FEDERAL ENERGY REGULATORY COMMISSION

I am pleased to enclose a copy of our Operation Inspection Report for DOE-Rocky Flats Dams A-4 B-5 and C-2 The field inspection of these dams was conducted on September 21 1994

Operation Inspection Report
for
Department of Energy

Dam Name Dams A-4, B-5 & C-2

1994 Elevations of Pond C-2 and Piezometers

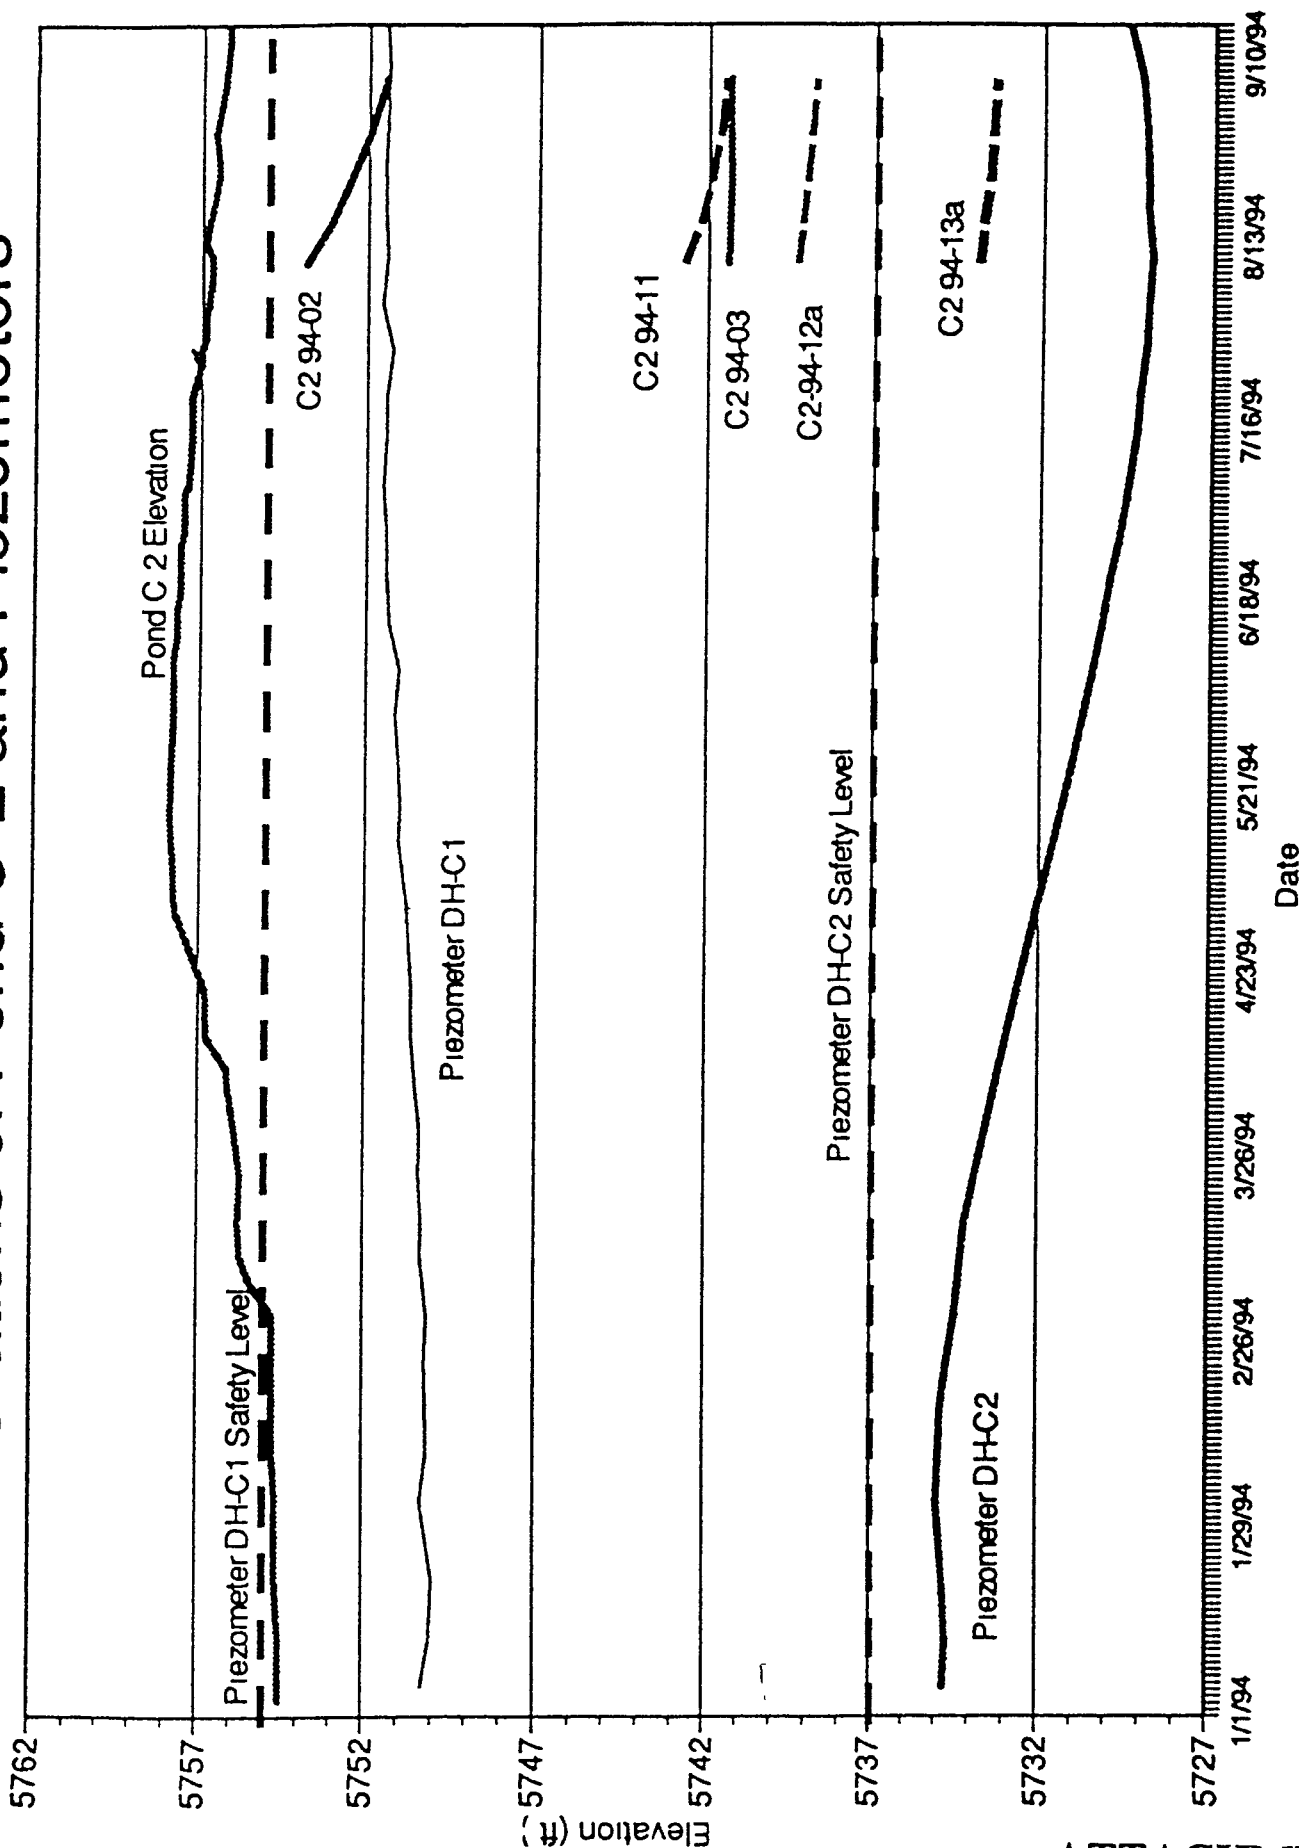
Dam C-2 Five additional piezometers were installed during June 1994. Two of them, C2-94-02 and C2-94-03 are at the crest and the other three, C2-94-11, C2-94-12a and C2-94-13a are at the toe of the dam. A view of the telemetry system at C-2 is seen in photo 25. The readings for these piezometers appear to be following the reservoir level in the dam, though more data will be required to arrive at any conclusions.

The reservoir levels for Dam C-2 have also been higher than originally intended. The highest elevation has been as high as 33% full.
